Item ID: D206-667-107BL Accept *N900040100* Setup Start *NS1*
 Revision ID: Stop *NS2*
 Item Name: Fwd Crosstube - Mid Height 206L / L1 / L3 / L4, Blue
 Start Date: 6/14/2017 Start Qty: 1.00 *1* Cust Item ID:
 Required Date: 6/29/2017 Req'd Qty: 1.00 *1* Customer:
 Reference:

DRAWING NO. D206-667-147
TITLE CROSSTUBE ASS'Y (206L MID FWD)

DRAWING NO. D206-667-147	TITLE CROSSTUBE ASSY (206L MID FWD)	REV. A	DART AEROSPACE LTD ENGINEERING ORDER		D.E.O. NO. D206-667-147-A-1	SHEET NO. SHEET 1 OF 1	SCALE NTS
DRAWN 92	CHECKED A.S.S.		MFG. APPR. [Signature]	APPROVED [Signature]		DE APPR. [Signature]	
DATE 11.07.15	DATE 11.07.20		DATE 11.07.21	DATE 11.07.21		DATE 11.07.21

DRAWING NO. D206-667-147	TITLE CROSSTUBE ASS'Y (206L MID FWD)	REV. A	DART AEROSPACE LTD ENGINEERING ORDER	D.E.O. NO. D206-667-147-A-2	SHEET NO. SHEET 1 OF 1	SCALE NTS
DRAWN AJS	CHECKED	MFG. APPR.	APPROVED	DE APPR.		
DATE 12.08.02	DATE 12.08.02	DATE 12.08.02	DATE 12.08.02	DATE 12.08.02	DATE 12.08.02

DETAIL P
 BONDING STRAP INSTALLATION 2 PL

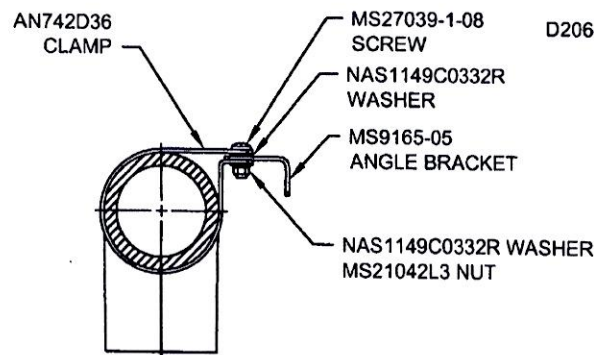
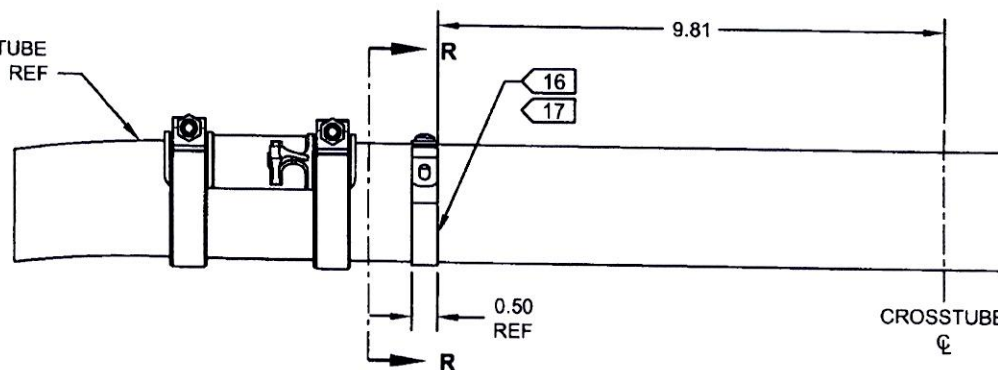
PURPOSE:

ADD ELECTRICAL GROUNDING STRAP

ITEM	QTY -147	PART NUMBER	DESCRIPTION
1	X	D206-667-147	CROSSTUBE ASSEMBLY (206L MID FWD)
10	2	AN742D36	CLAMP
11	2	MS9165-05	ANGLE BRACKET
12	2	MS21042L3	NUT (OR MS21042-3)
13	2	MS27039-1-08	SCREW
14	4	NAS1149C0332R	WASHER (OR AN960C10L)

- 16) MASK AREA UNDER CLAMP PRIOR TO PAINTING
 17) SEAL EDGES WHERE AN742D36 CLAMP MEETS WITH THE CROSSTUBE USING SIKAFLEX-2411-291 OR MIL-S-8802 CLASS B2 OR PROSEAL 890 SEALANT
 18) PERFORM RESISTANCE CHECK TO ENSURE MAX RESISTANCE IS 10 MILLIOHMS
